294 – 295 High Holborn,  
London WC1V 7JG

Basement Impact Assessment  
Audit

For  
London Borough of Camden

Project Number: 12466-92

**MOVEMENT MONITORING POINTS  
SHEET 1**

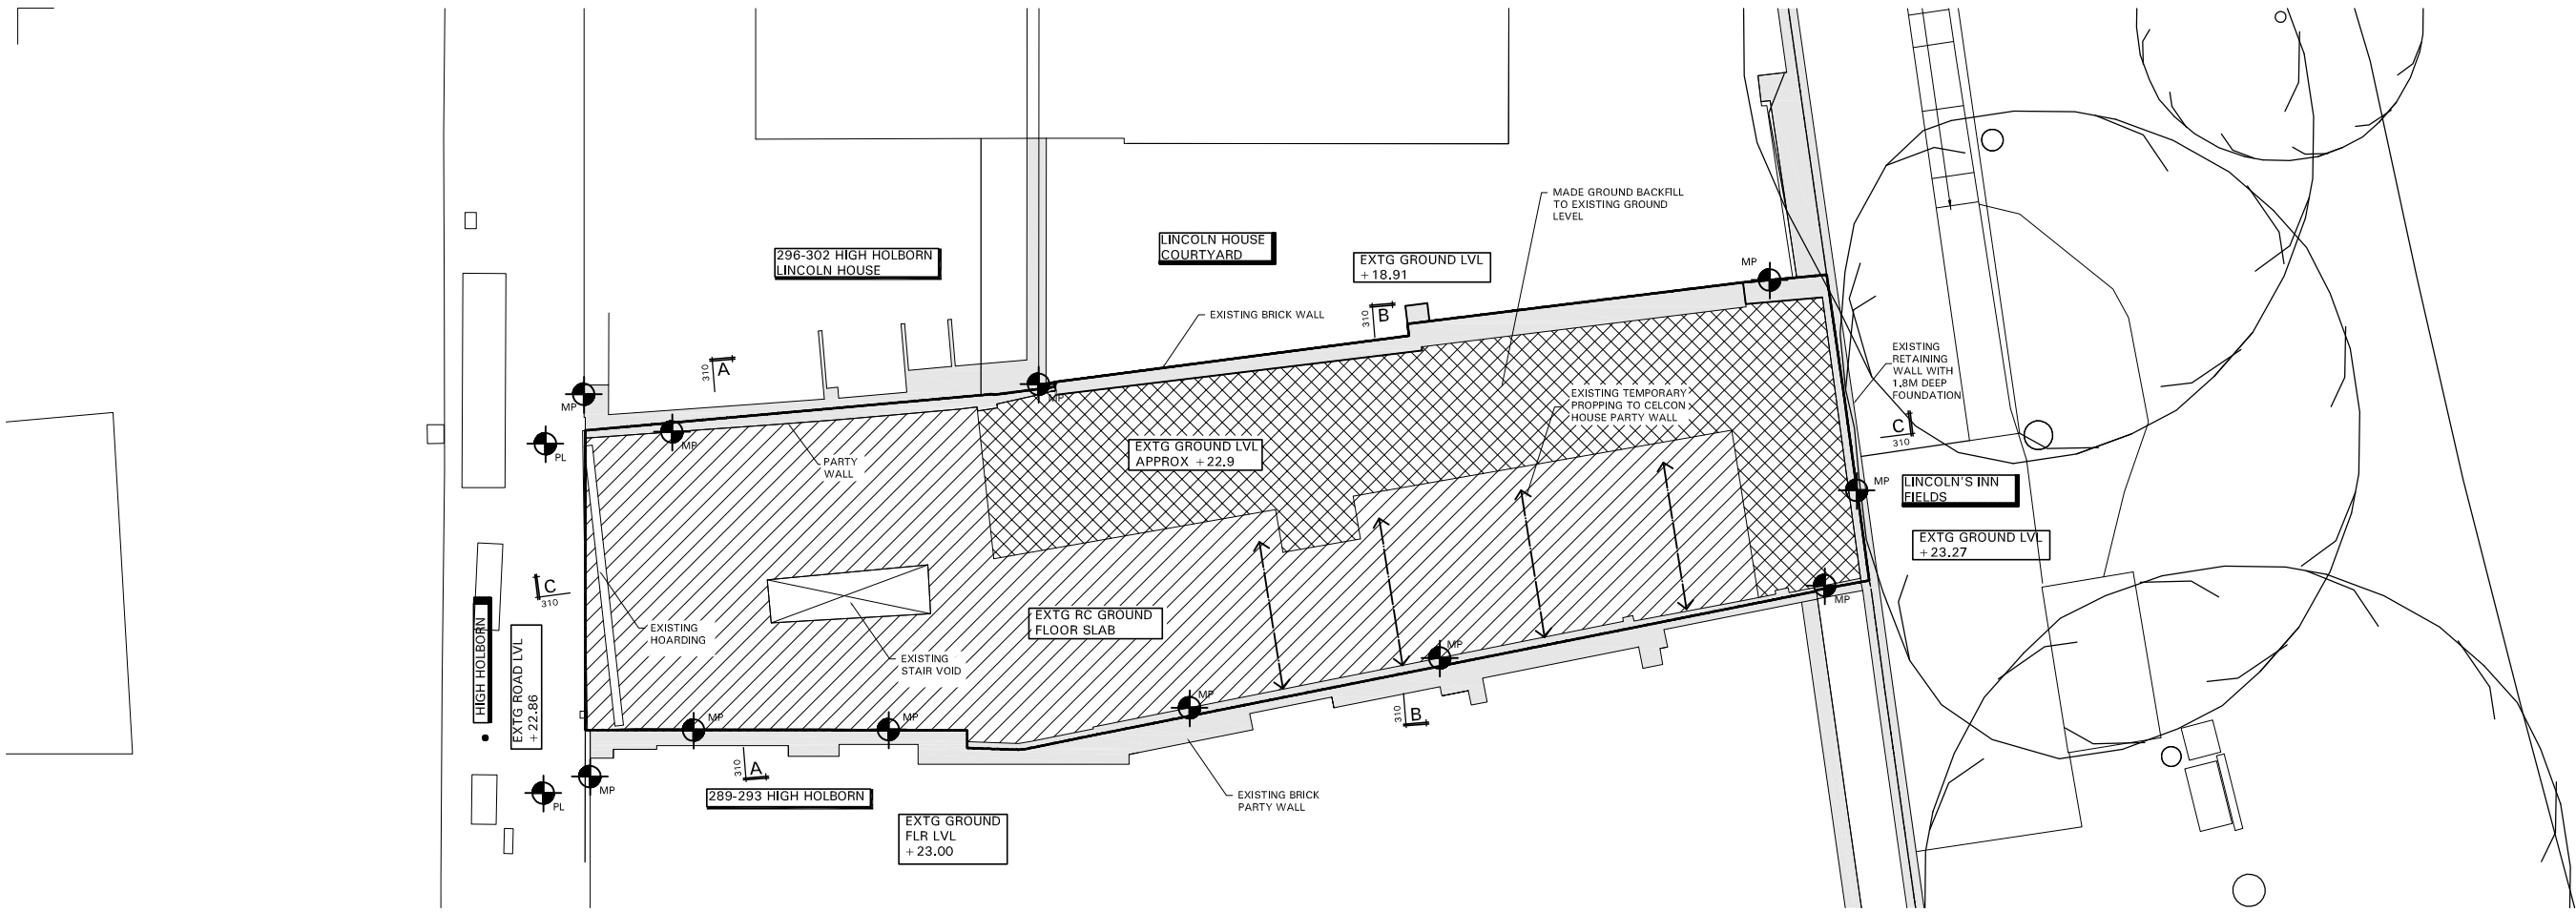
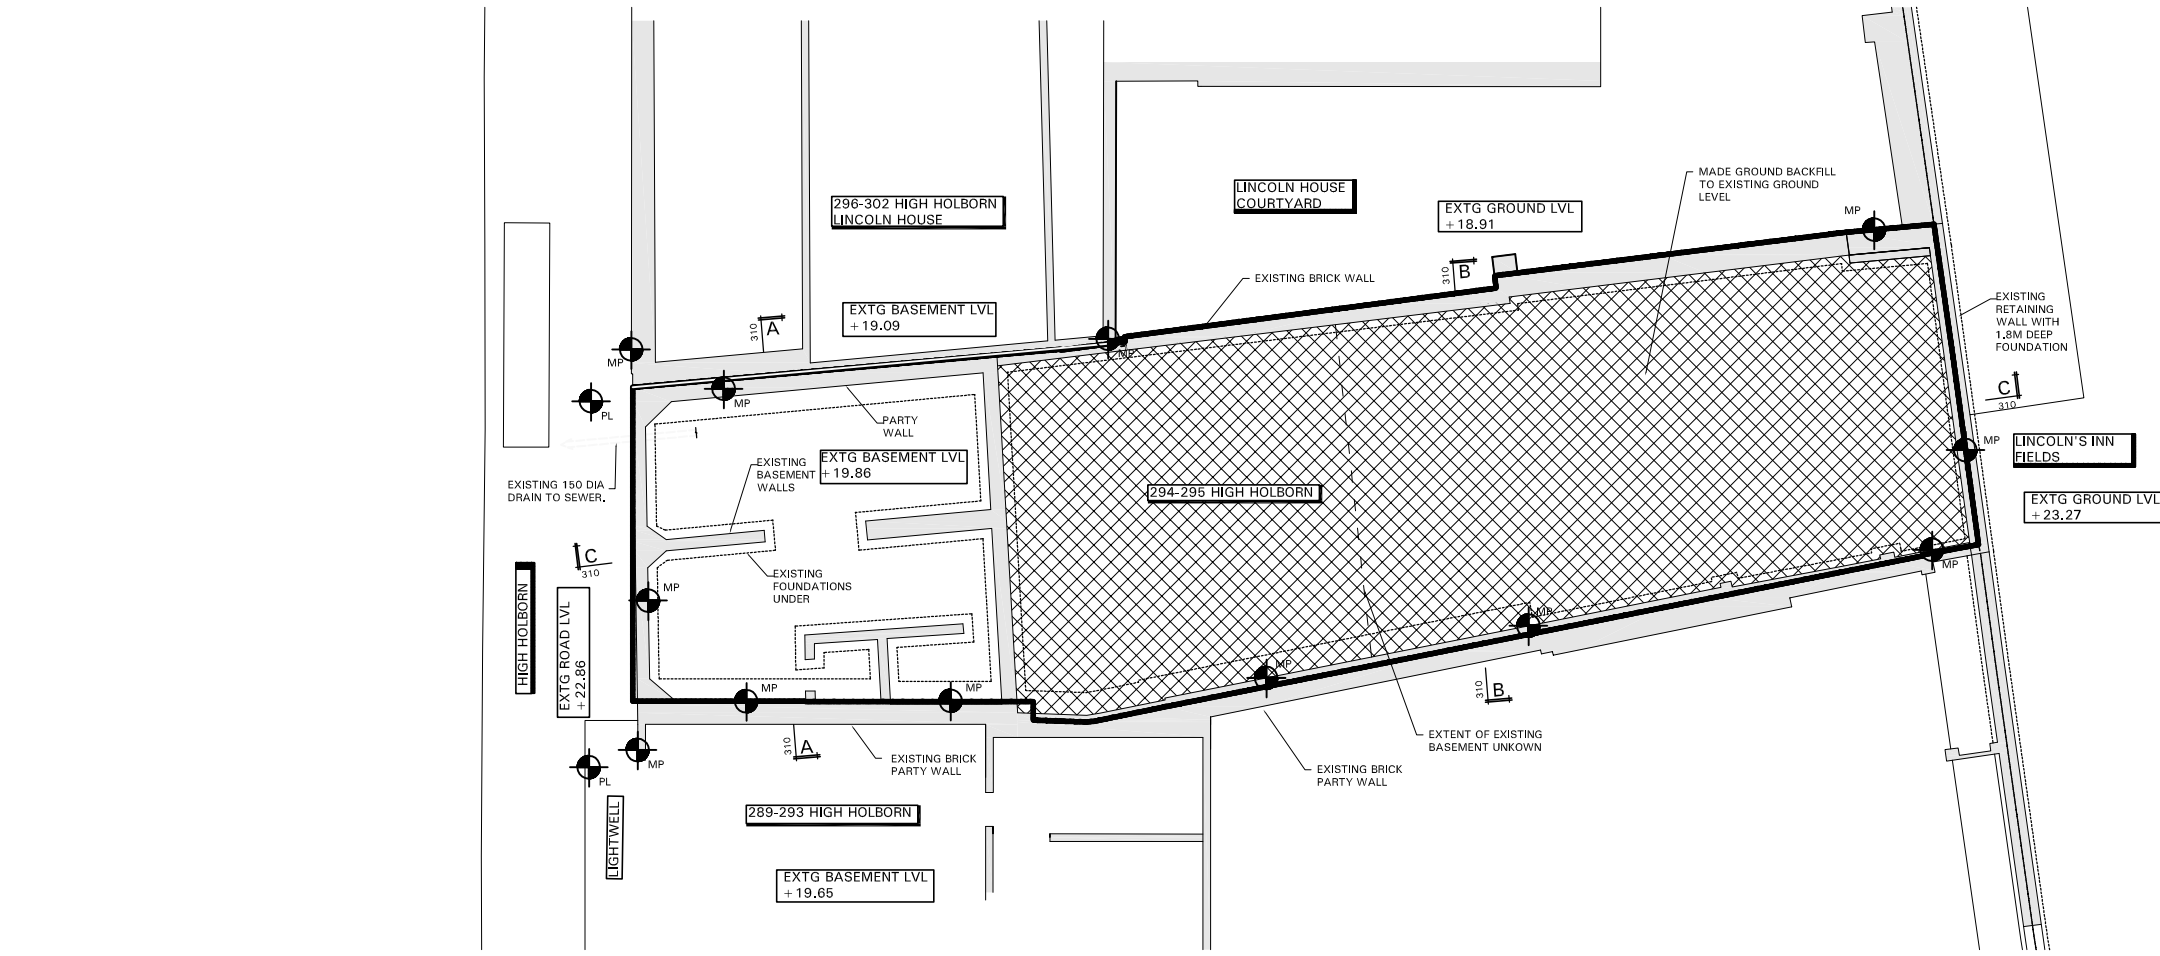
- 4.17. An outline methodology and guidance for monitoring structural movements and limiting damage impacts has been provided by MBP, stated in their Structural Engineering Report with accompanying drawings indicating the layout of monitoring points. In the revised submissions, the trigger values to be adopted have been updated to reflect the movement sensitivities indicated in the CGL report. Amber triggers are at 4mm and red triggers are 7mm.

P2	240817	UPDATE TRIGGER LEVELS	JMG
P1	200317	PRELIMINARY PLANNING	JMG
Rev	Date	Description	By
